UNITED STATES PATENT AND TRADEMARK OFFICE

APPLICATION NO.	FILING DATE	FIRST NAMED INVENTOR	ATTORNEY DOCKET NO.	CONFIRMATION NO.
09/710,362	11/10/2000	John C. Connolly	PLW 13206	5398

<b>Office Action Summary</b>	Applicant No. .	Applicant(s)
	09/710,362	CONNOLLY ET AL.
	Examiner	Art Unit
	James A. Menefee	2828

## **DETAILED ACTION**

**FIG. 13**

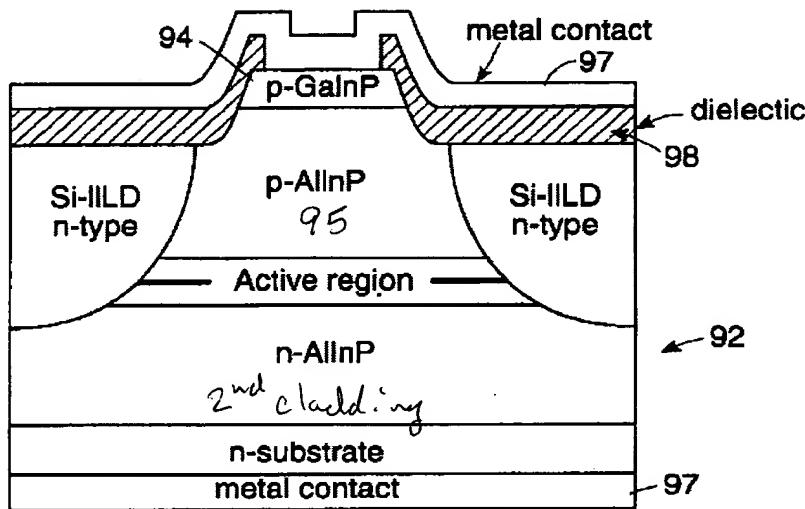
Regarding claim 24, Beernink discloses, especially in Figs. 11-13 and the discussion thereof on col. 8, a ridge waveguide semiconductor laser diode comprising a first cladding layer 95 having a ridge with a first width at the bottom of the ridge, a second cladding layer, an active layer disposed between the first and second cladding layers, a first conductor layer 97 disposed on top of the ridge, and a second conductor (also 97) for conducting current through the active

layer. The active layer has a defined gain region (the part marked "Active region") that conducts the current and has a width greater than the width of the bottom of the ridge. There are reduced conductivity regions within the active layer and flanking the defined gain region.

Regarding claim 31, the reduced conductivity regions are implanted with high-energy ions.

Regarding claim 34, Beernink discloses that there may be an insulating layer 98 disposed adjacent the first conductor layer 97.
